Staff Report

To: Salt Lake City Planning Commission
From: Nannette Larsen, Senior Planner, 801-535-7645, nannette.larsen@slcgov.com
Date: November 16, 2022
Re: PLNPCM2022-00567, G3 Apartments

Design Review

OPEN SPACE CALCULATION

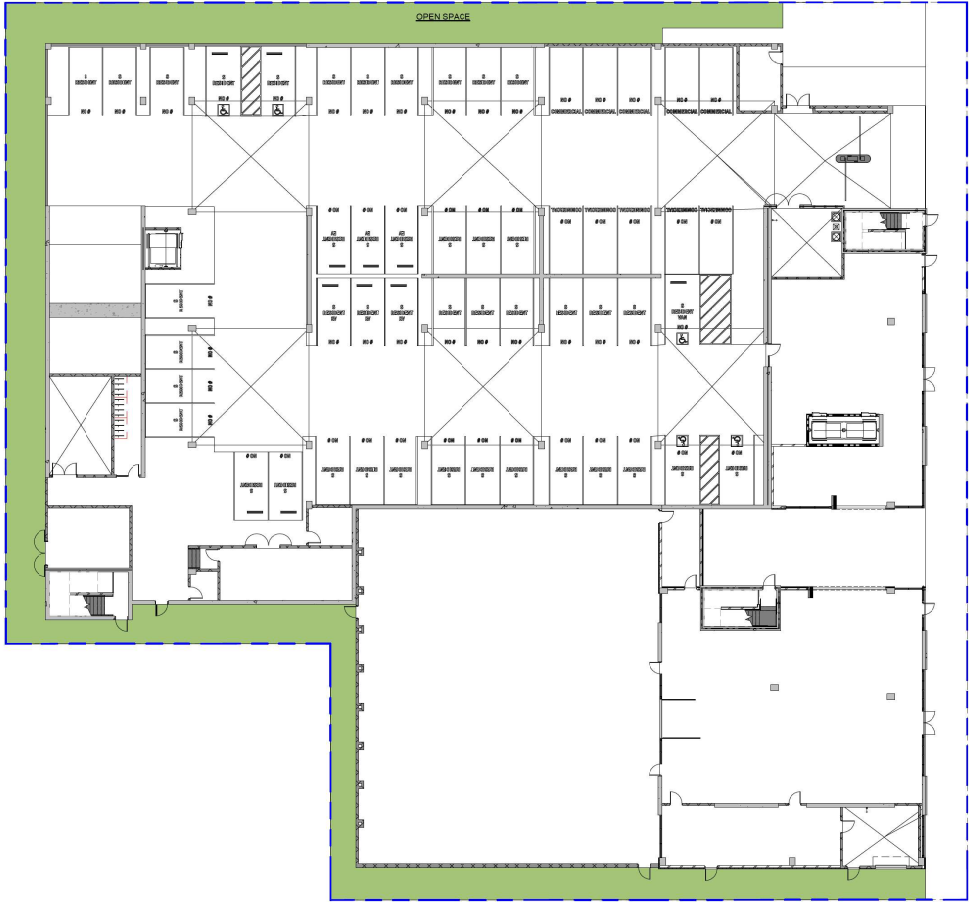
The second standard required for approval of a Design Review in the CG district is met by the additional landscaping on the interior side and rear yard areas. The requested height is 82', which would allow for two additional building floors that will be allowed through the Design Review. Approximately 5,100 square feet of additional landscaping is required, the G3 Apartment project will provide 5,900 square feet of additional landscaping.

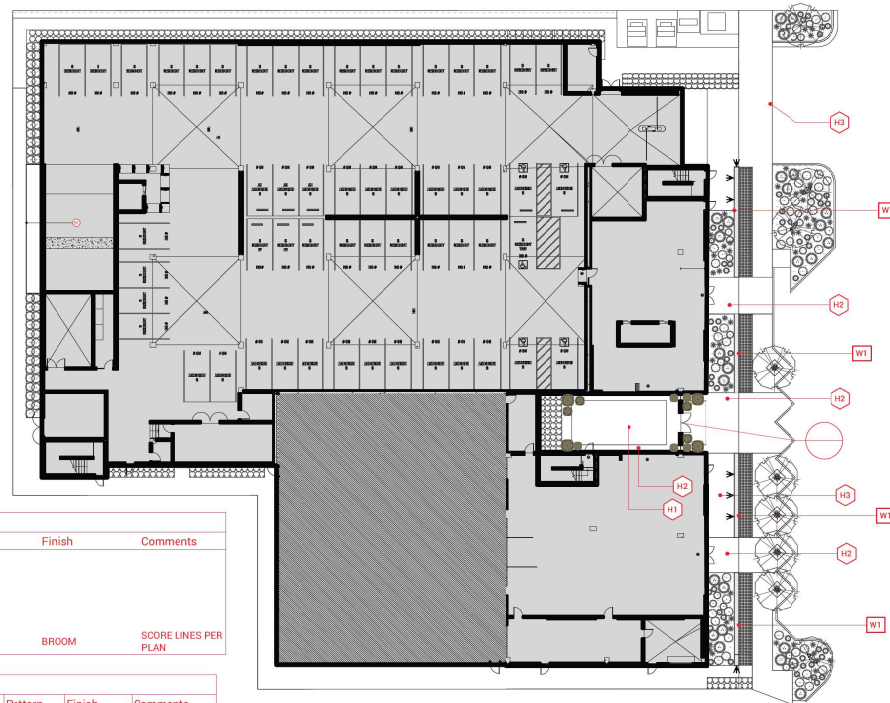
1. The uplighting proposed in the landscaping is replaced with light fixtures which are directed downwards.
2. A public easement will be recorded on the property for the midblock walkway.
3. Plaza seating will be 30" wide, at least 16" tall, and 30" in depth.
4. A representative of the property owner work with an artist of the property owner's choice for the installation of art that is visible from either the midblock walkway or the public sidewalk.
